**Re: Appeal of Preliminary Partition Decision**

*Project Name:* SW 155<sup>th</sup> Avenue 3-Lot Partition  
*Applicant:* ADTM Development, LLC  
*Case File No.:* LD2016-0002, TP2016-0003, FS2016-0001  
*Appeal No.:* APP2016-0003  
*Project Location:* 10510 SW 155<sup>th</sup> Avenue, Tax Lot 00100 of Washington  
County's Tax Assessor's Tax Map 1S132BD

Ex. 9

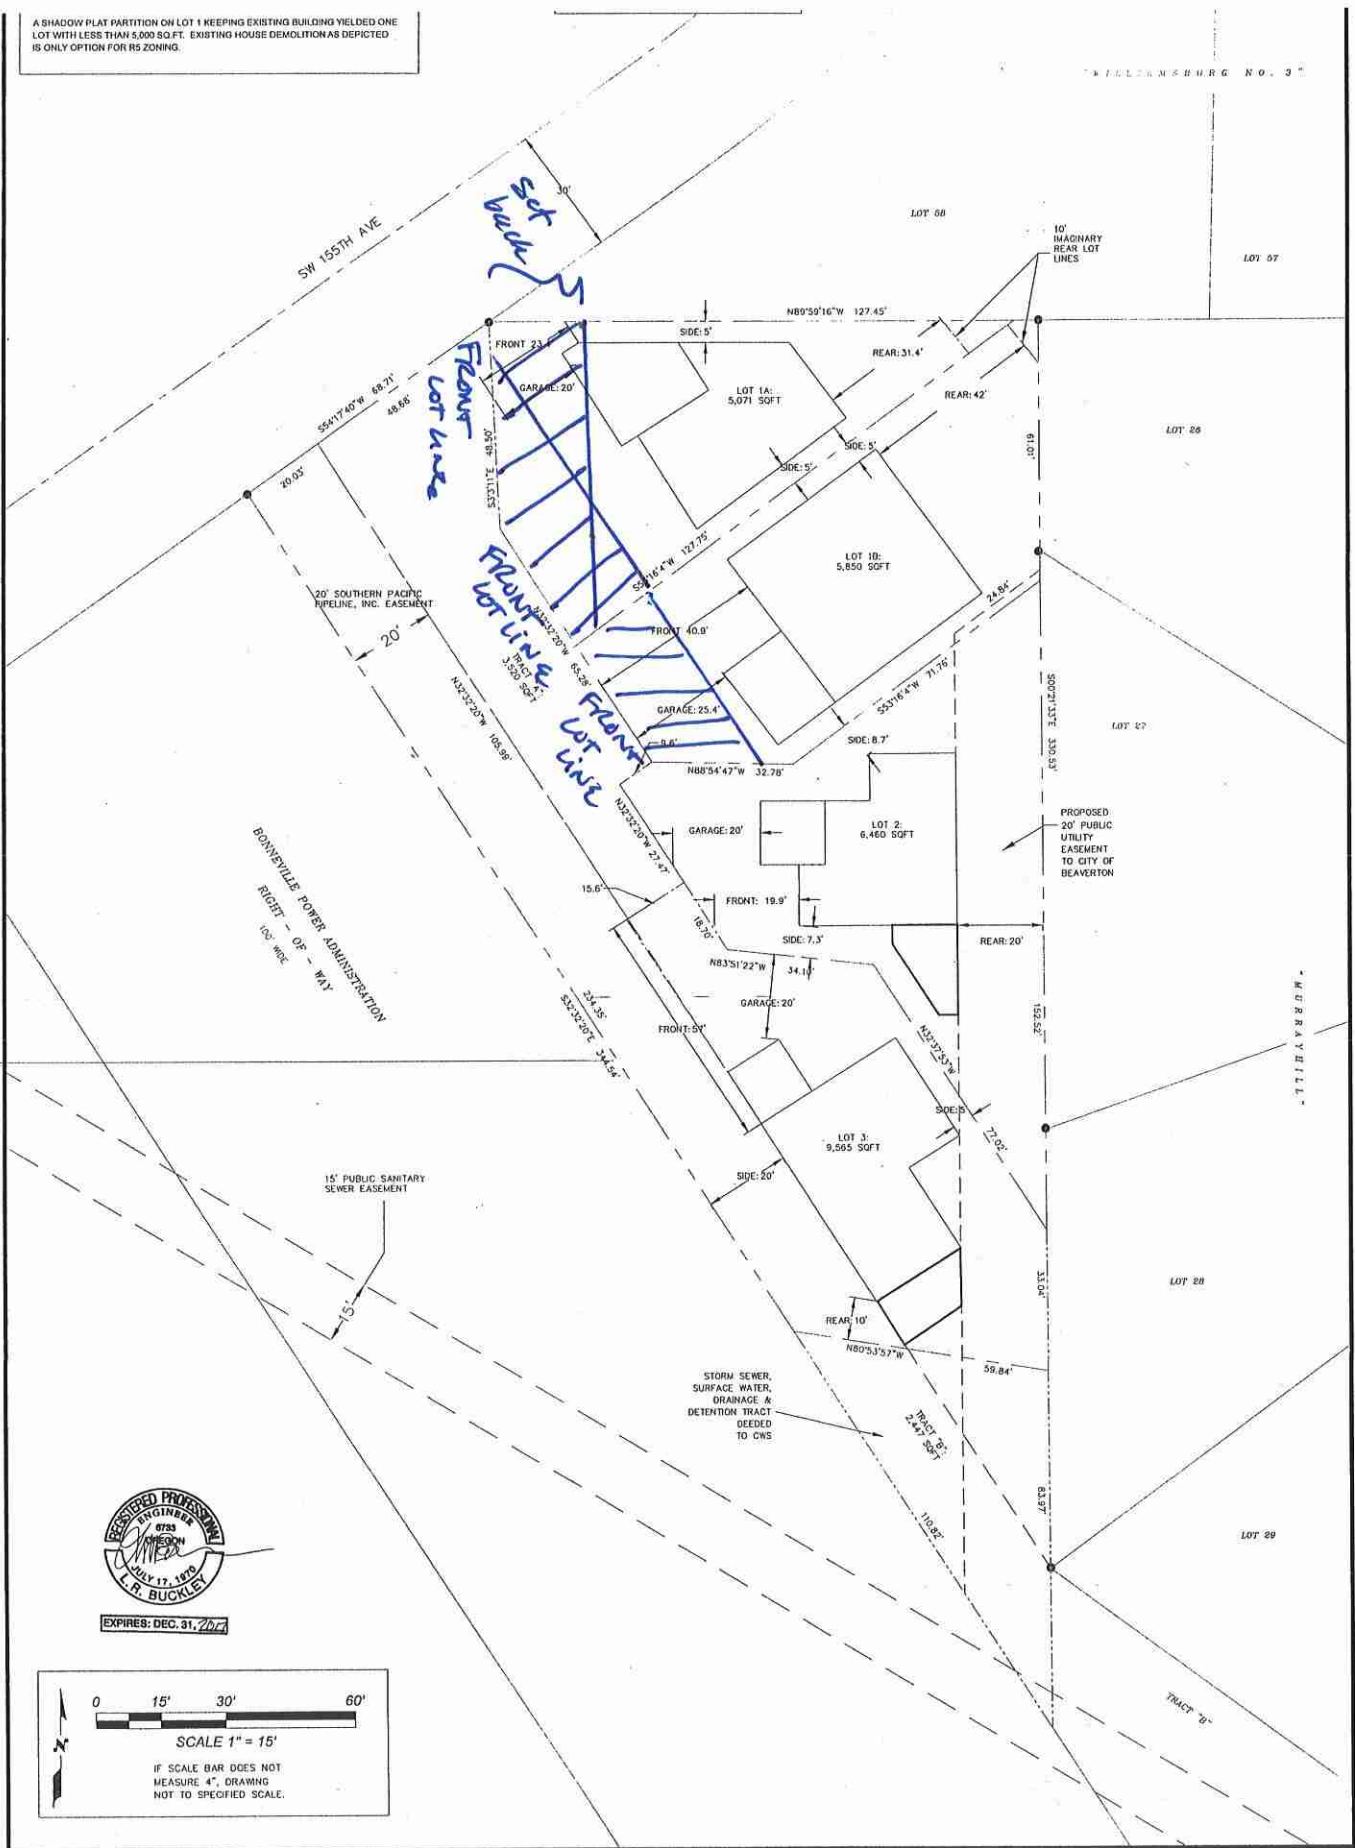
At the Hearing, and in our prior written submissions, we explained in detail how the Applicant has failed to follow the setback rules for the front yard calculations on both “Lot 1” and “Lot 2.” The exact same logic must be applied to the Applicant’s “shadow plat.” This simply clarifies that the Applicant has similarly failed to follow those exact same definitions/rules when showing the setbacks for its “shadow plat” on “Lot 1.” *See* Ex. 9 (shadow plat plans showing setback area per BDC definitions).

A SHADOW PLAT PARTITION ON LOT 1 KEEPING EXISTING BUILDING YIELDED ONE LOT WITH LESS THAN 5,000 SQ.FT. EXISTING HOUSE DEMOLITION AS DEPICTED IS ONLY OPTION FOR R5 ZONING.
